# CITY OF ALBUQUERQUE

**Re: Route 66 Malt Shop Grill & Parking Lot, 3800 Central Ave. SE,  
Request for Permanent Certificate of Occupancy - Approved  
Engineer's Stamp dates: 12-15-09 & 4-5-10, (K-17/D103)  
Certification dated: 08-03-10**

**Re: Rte 66 Malt Shop Parking Lot Grading Plan**  
**Engineer's Stamp dated 4-5-10 (K17/D103)**

**Re: Route 66 Malt Shop and Grill, 3800 Central Ave SE, Grading and Drainage Plan**

A-2

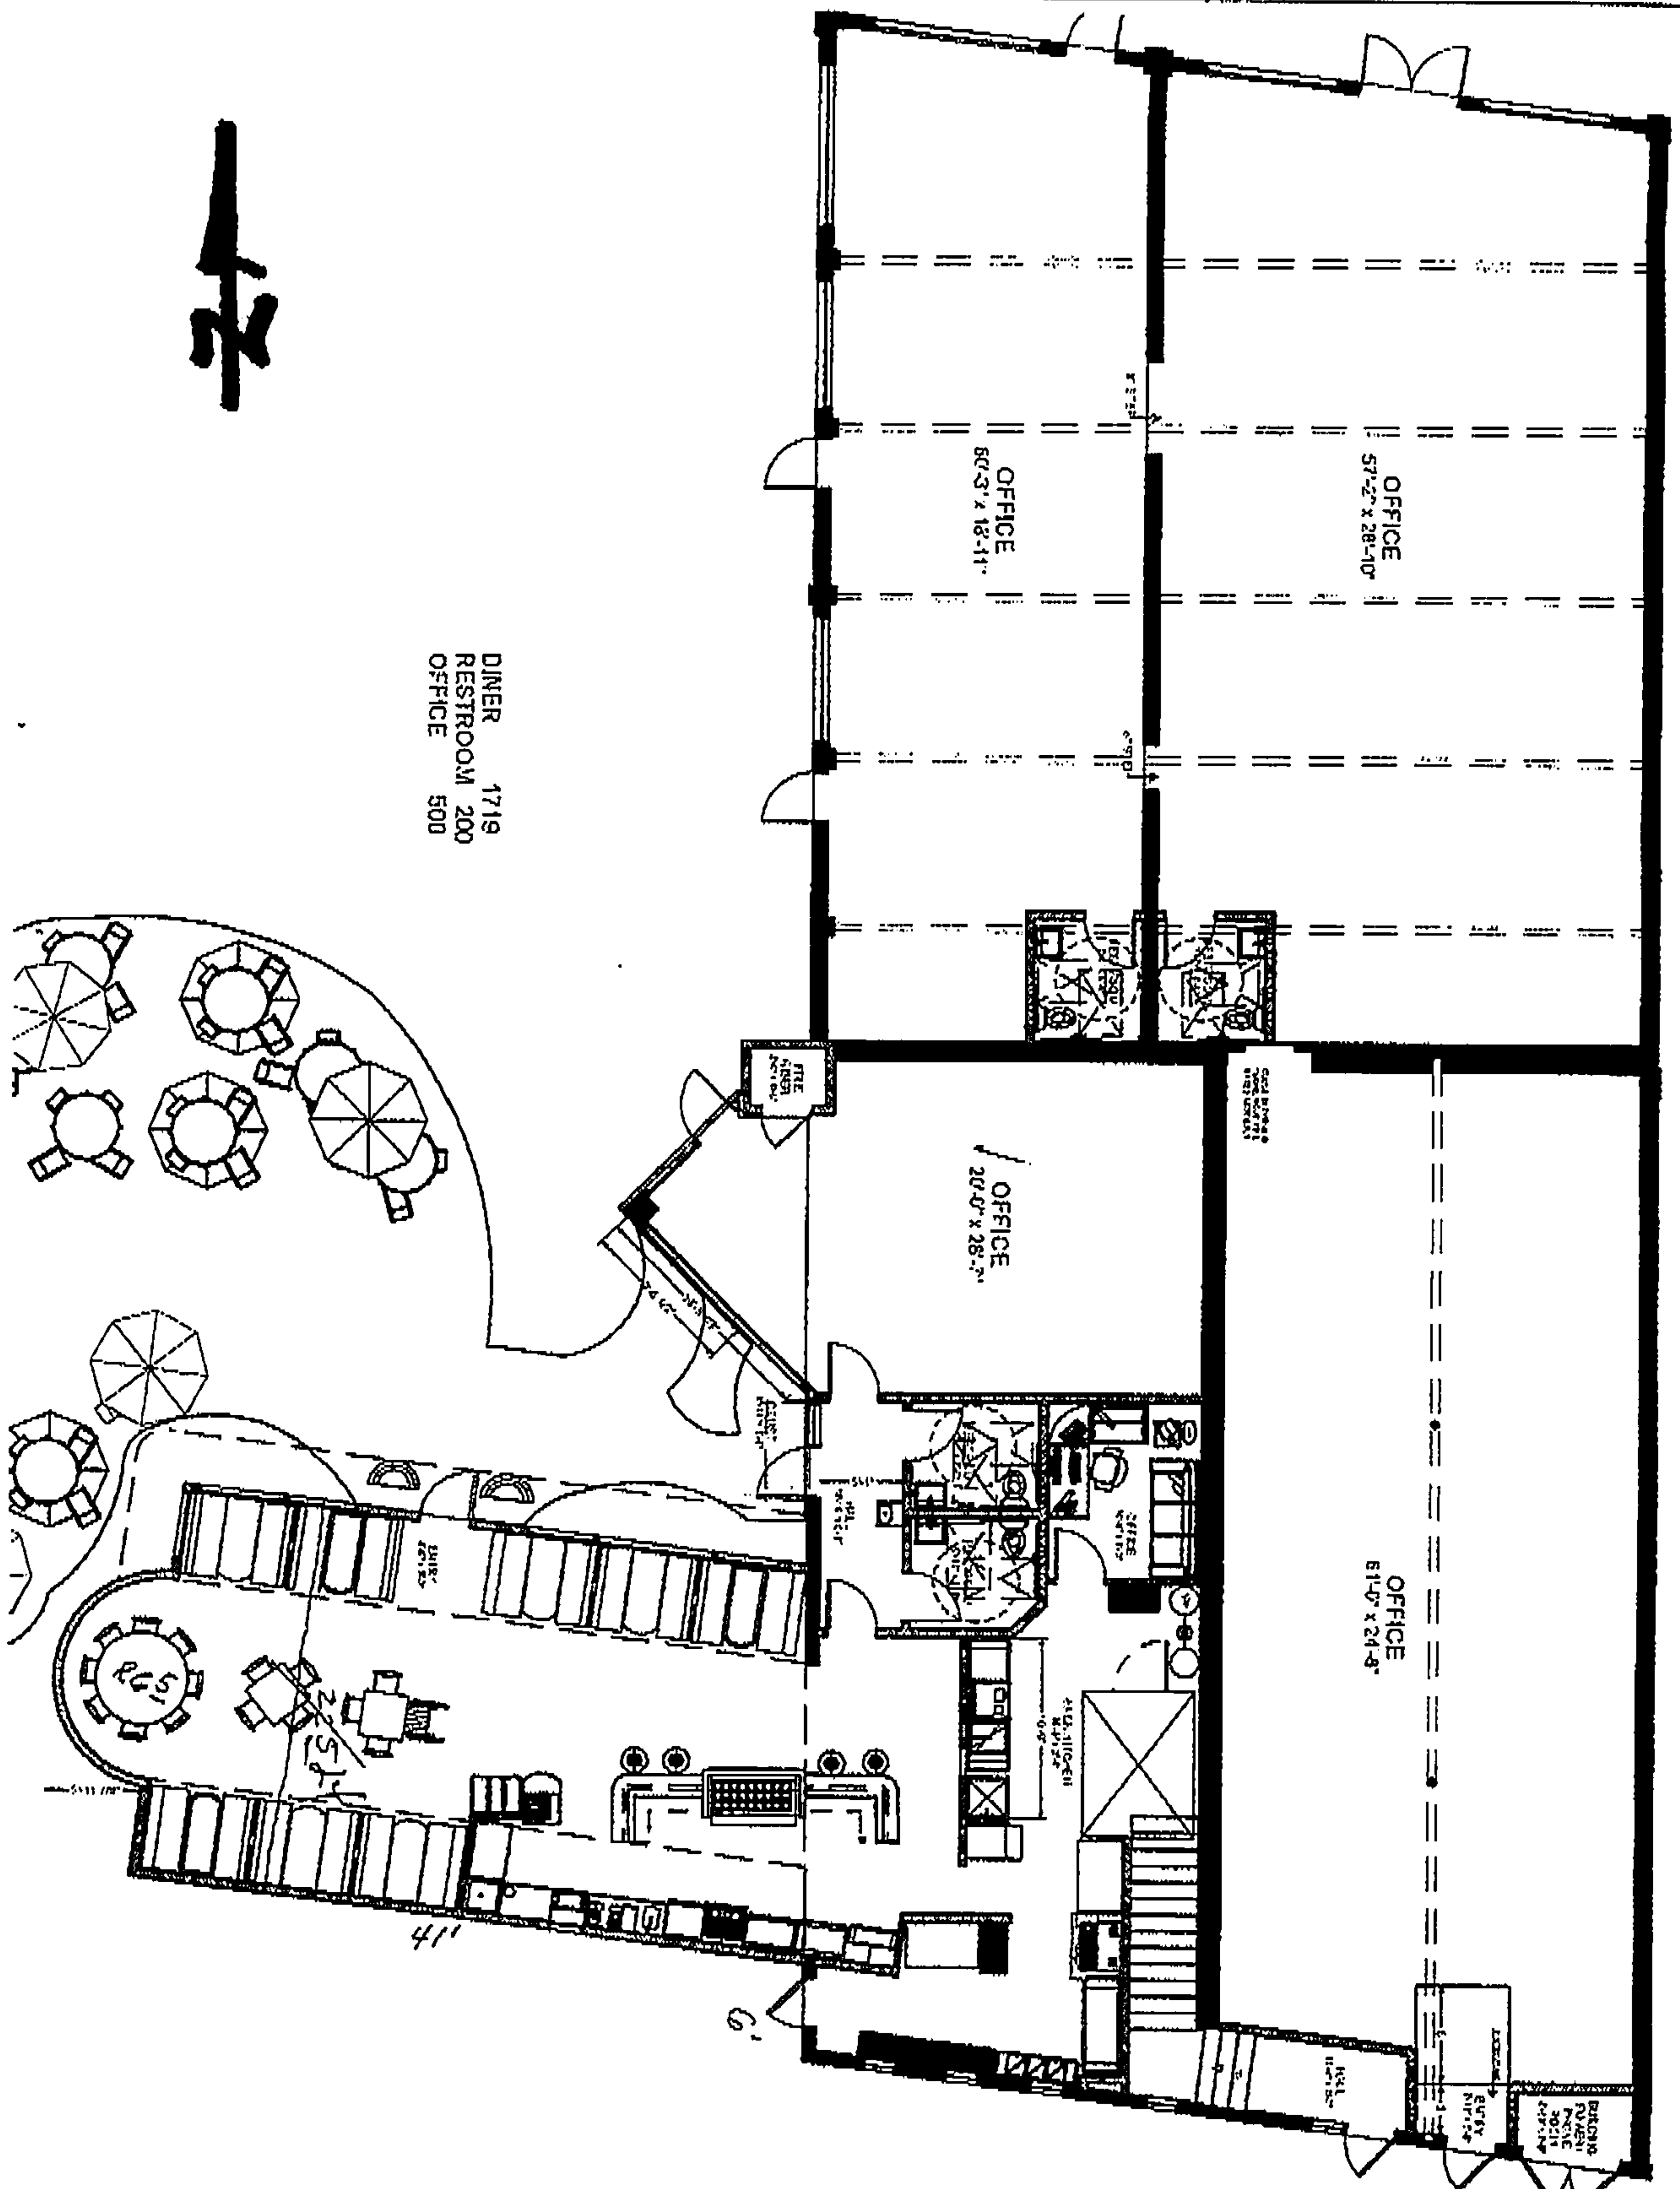
I've already heard from the City Hydrology section - and have addressed their concerns. In order, to match the existing floor elevation (which is below the AO1 flood elevation), we are required to define the shop as an addition to the existing building. As long as we show access between the two spaces (I sent them a floor plan depicting this), AND that the value of the Addition is less than 50% of the total structure... (existing+proposed).

- Curtis - please find fax of Floorplan of Addition showing Access To Existing
- please Note # 2 of Report verbiage ... reference to "1200 SF Addition"
- I have changed "Adjacent to" → within
- I have a call to owner re: Value Ratio

Please be advised that we are planning to build a 1,750 square foot addition (approximate size) to the southwest corner of the existing 9,000 first floor structure currently located the above referenced property. This addition will open into and be an integral part of the existing building and will represent significantly less than 50% of the value of the combined building.
